Agenda
City of Springboro Planning Commission Meeting
Wednesday, October 11, 2023, 6:00 p.m.
Council Chambers, City Building, 320 West Central Avenue

Background Information & Staff Comments/Recommendations
City of Springboro Planning Commission Meeting
Wednesday, October 11, 2023, 6:00 p.m.
Council Chambers, City Building, 320 West Central Avenue

Site Plan Review, 1345 Lytle-Five Points Road, Ravine at Settlerspointe assisted living facility

B. Final Approval, Rezoning, R-1, Estate-Type Residential District, to PUD-R, Planned Unit Development-Residential, 1525 South Main Street (SR 741), proposed single-family residential subdivision

FILE NAME	VICINITY
DRAWN BY	JBP
CHECKED BY	JSP
PROJECT No.	WARSPR2303
DATE	09-21-2023
SHEET NUMBER	1 OF 4

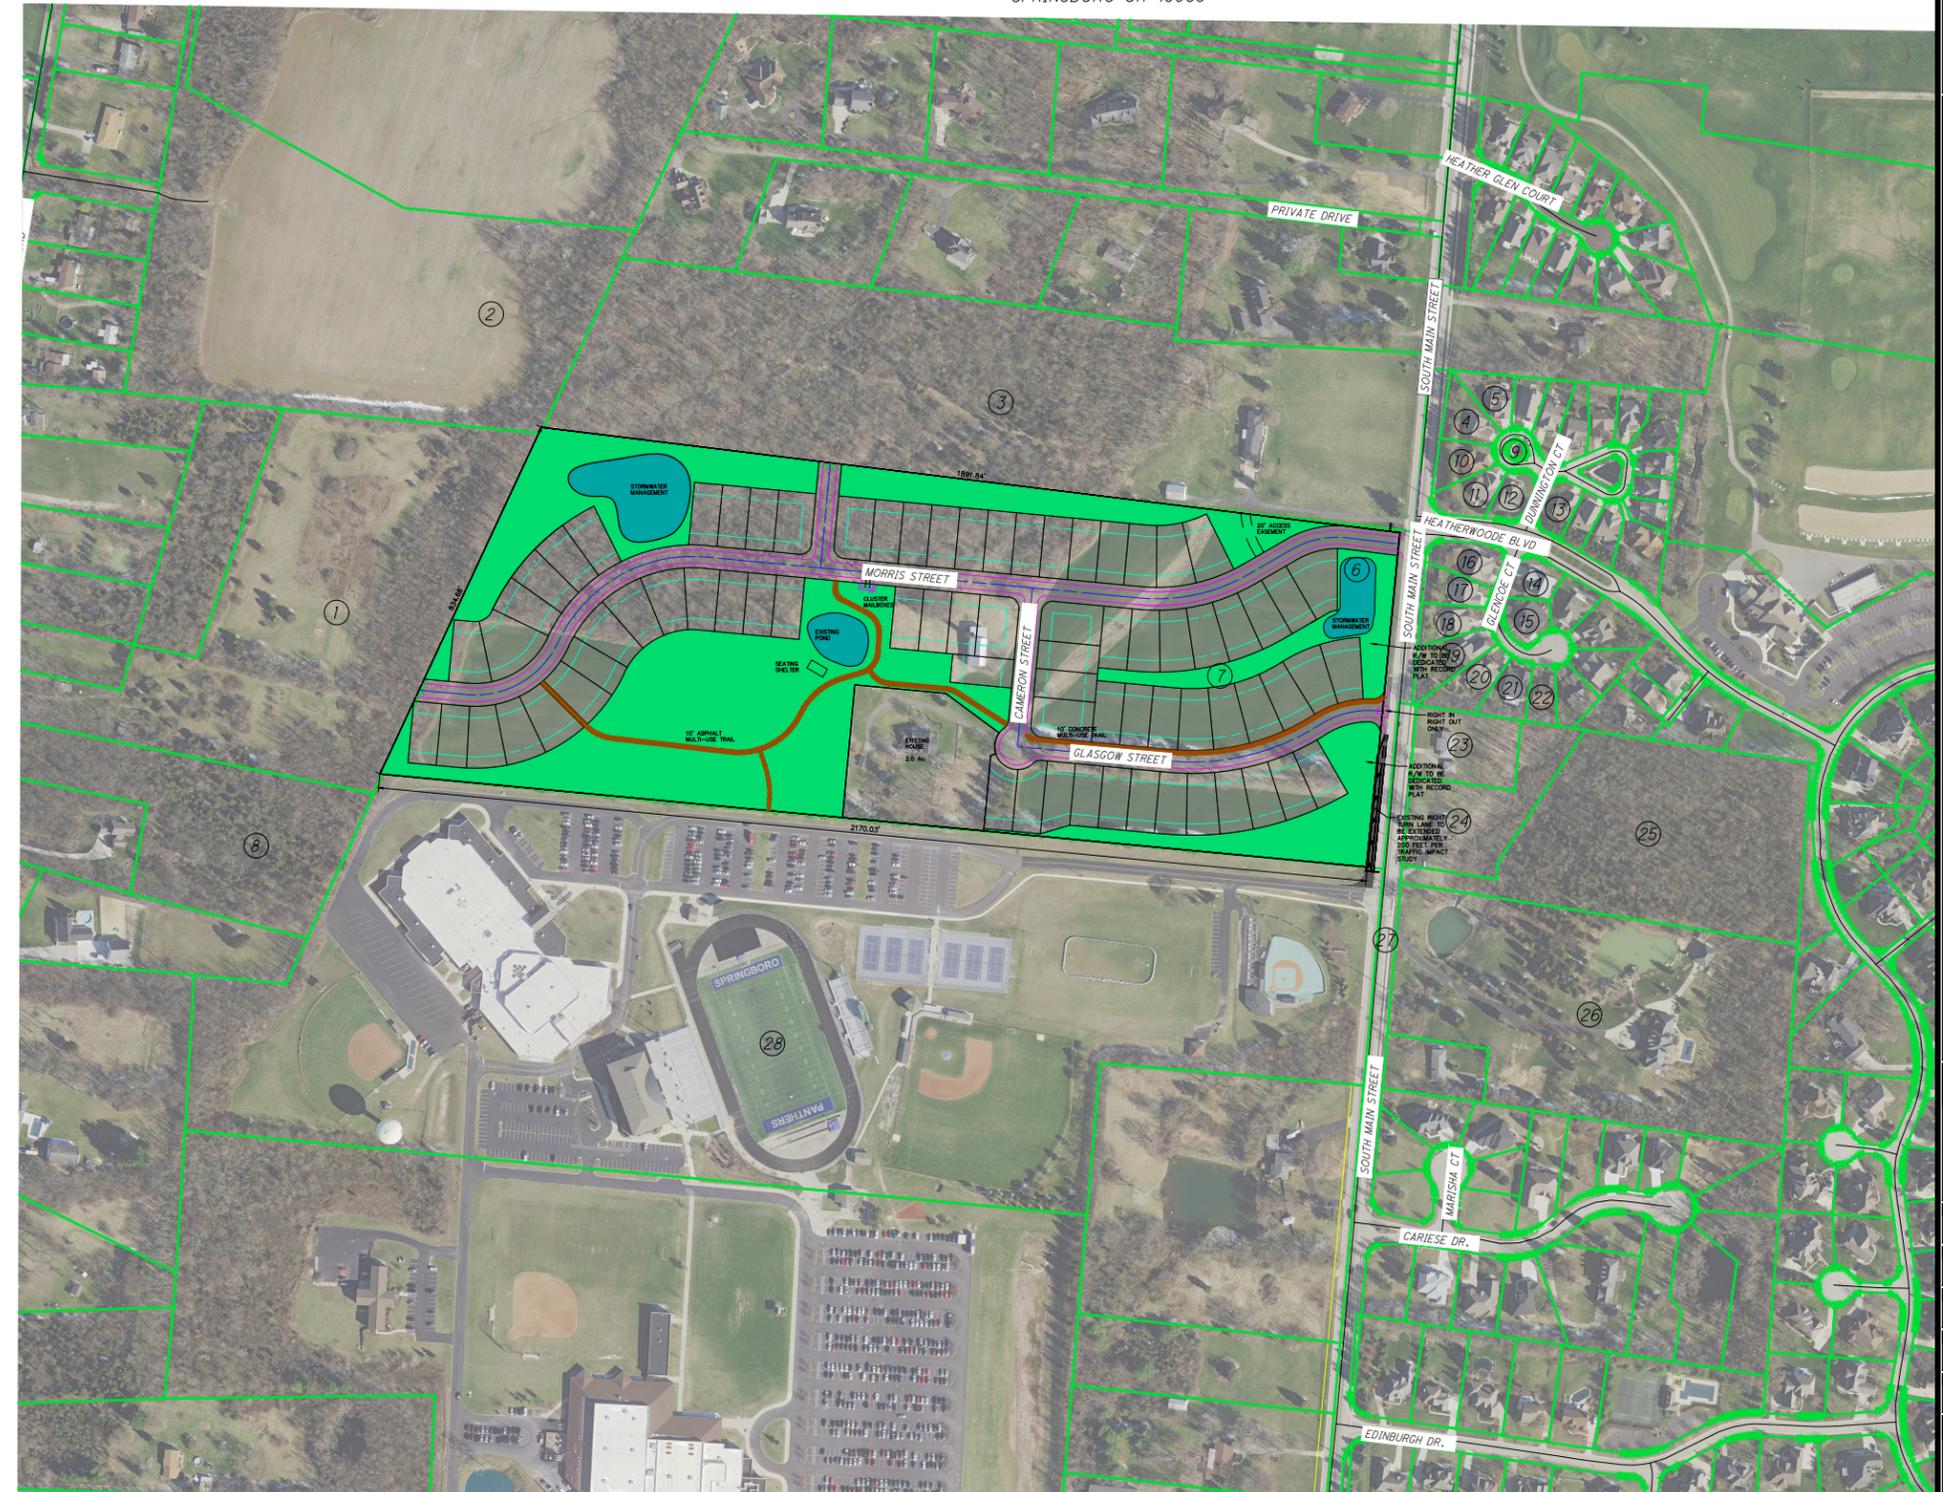
3. Provide a minimum 50% ranch-type home product as part of proposed general plan.
4. Reorganize the proposed open space plan so that it provides future residents with more quality open space this is contiguous and usable, then drains the property, then buffers neighboring development in that preference order.

5. Proposed east-west multiuse trail needs to be more fully developed in final development plan stage of process and rerouted. Meantime realign west end to follow proposed Morris Street to west property line, and include stub street to north property, and to any potential connection to the school campus to the south. Access for all members of the public needs to be provided for in the layout and location.

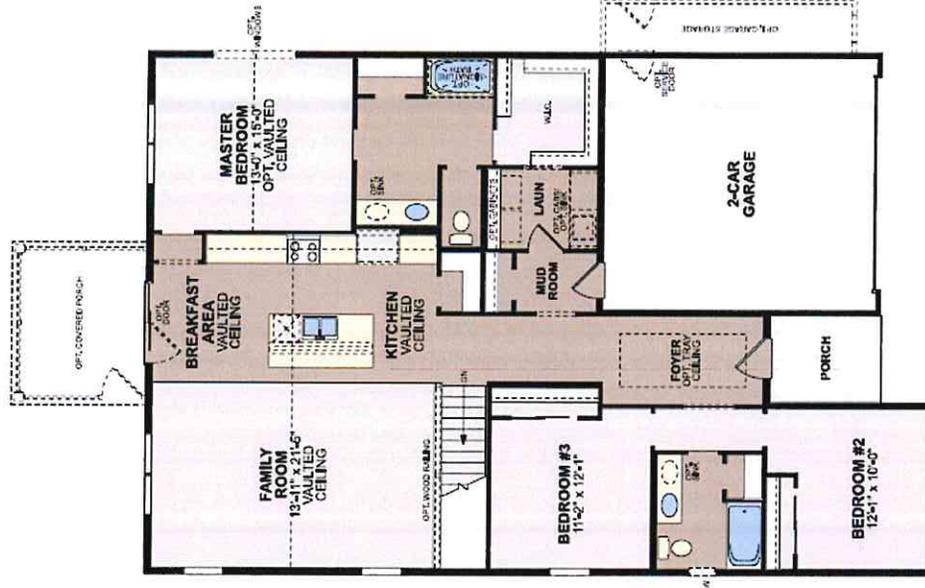
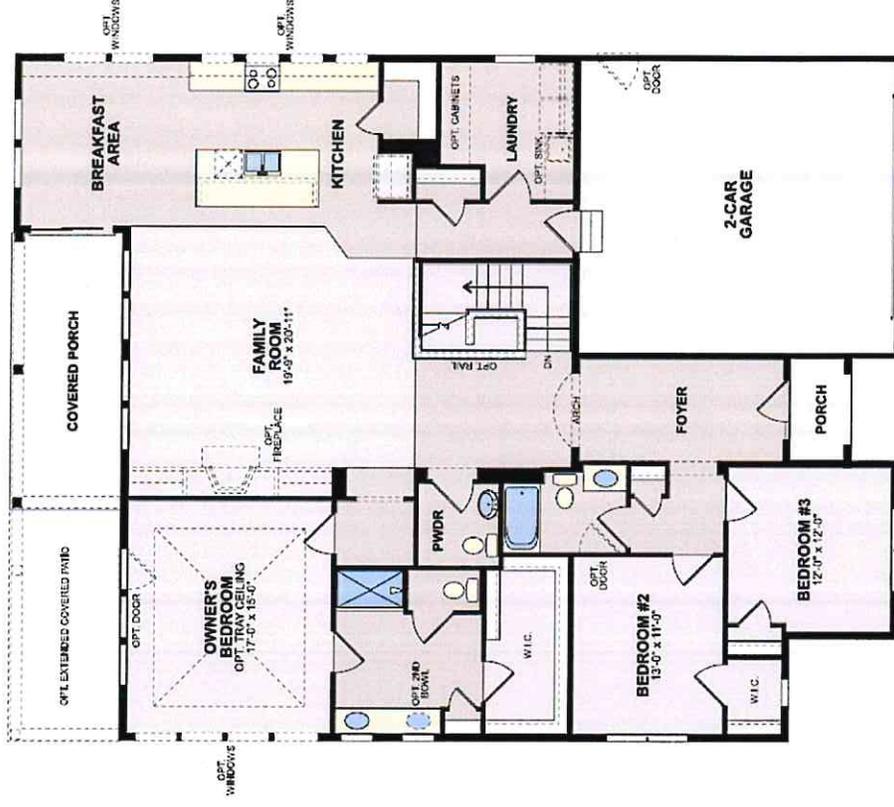
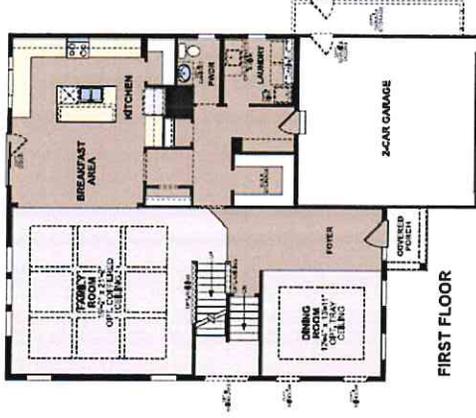
1. Home plans to comply with Section 1264.06, Design Standards for Single-Family Detached Dwellings, of Planning and Zoning Code.
2. Proposed volume of vinyl siding on sample homes included in submittal is high. Applicant to propose exterior minimum percentage of brick, stone, cement board, and other materials for use in the subdivision.
